From: Nicholas Davies <nbdavies@gmail.com>
Sent: Monday, January 12, 2026 7:25 PM
To: sean.malloy@cityofmadison.com
Cc: Planning <planning@cityofmadison.com>; joe@jdmccormick.com; kburow@knothebruce.com; njoh@vierbicher.com; egor@vierbicher.com
Subject: Traffic Engineering conditions of approval for 3205 Stevens Street: missing bike parking

From: [James Ream](#)
To: [ulrike dieterle](#); [Plan Commission Comments](#)
Cc: [Jonathan Becker](#); [Vidaver, Regina](#)
Subject: Public Comment / JAMES REAM / 3205 Stevens Street (File# 90615) Pedestrian Pathway on Eastside of Woodland Reserve Property
Date: Monday, January 12, 2026 2:58:48 PM

From: [Nicholas Davies](#)
To: [Plan Commission Comments](#)
Cc: joe@jdmccormick.com; kburow@knothebruce.com; njoh@vierbicher.com; egor@vierbicher.com; [Vidaver, Regina](#)
Subject: Concerns with 3205 Stevens Street plans (90615)
Date: Sunday, January 11, 2026 12:48:51 PM

From: [Craig Weinhold](#)
To: [Plan Commission Comments](#)
Cc: [Vidaver, Regina](#)
Subject: Plan Commission / 3205 Stevens St / Woodland Preserve / Please keep the path!
Date: Saturday, January 10, 2026 5:30:20 PM
Attachments: [image\(3\).png](#)

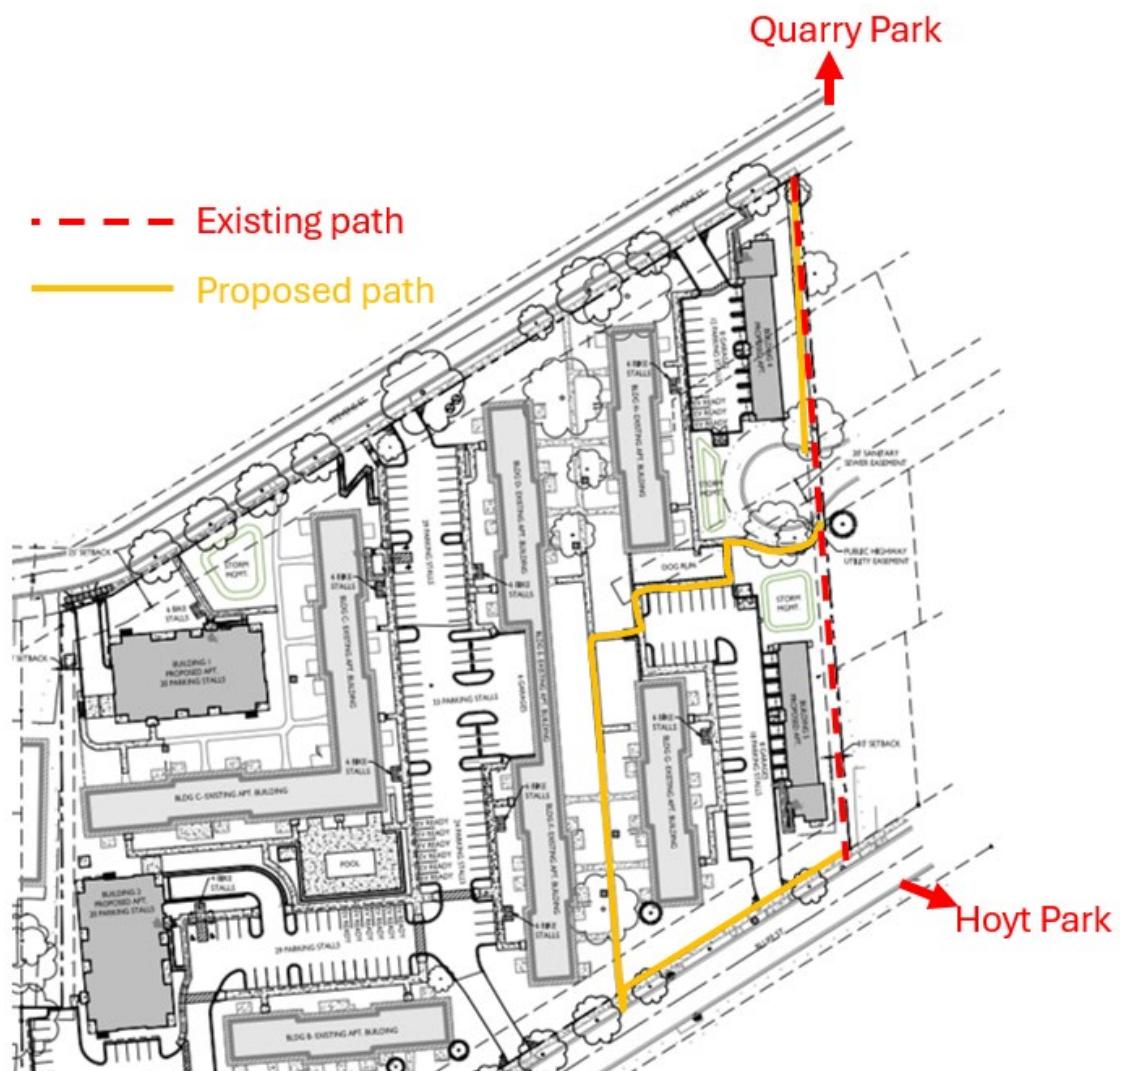
In the Woodland Preserve development, please insist that the east side path between Bluff St and Stevens St be maintained and improved. It ought to be an ADA-friendly bike and pedestrian path. Even in its derelict state, it is heavily used (see all the photographs in separate public comment submitted on January 1 and 5 by Mary and John Sheean). It is the most direct link between Hoyt and Quarry parks. It also is the most direct link between homes south of Hoyt Park to University Avenue businesses and the Shorewood BRT bus stop. Nearby Ridge St has traffic and no sidewalks. Losing the path would be a loss for the community and the City.

The developer's proposed alternative route (in orange in the diagram below) is not suitable. It is longer, zig-zaggy, and makes one feel like they are interloping through residents' back yards.

The developer cites a problematic guy wire and the need for grading as reasons to remove the path. The guy wire is a trivial problem; Madison has many paths and sidewalks that go under them.. Grading is a problem of the developer's own creation; it's needed only because building #5 is placed in a corner of the property with substantial grade change and drainage difficulties, Building #5 is also a problem for neighbors, as it will tower 30' over the nearby single story properties on McKinley St. The developer has not produced any renderings of what their development will look like from McKinley St.
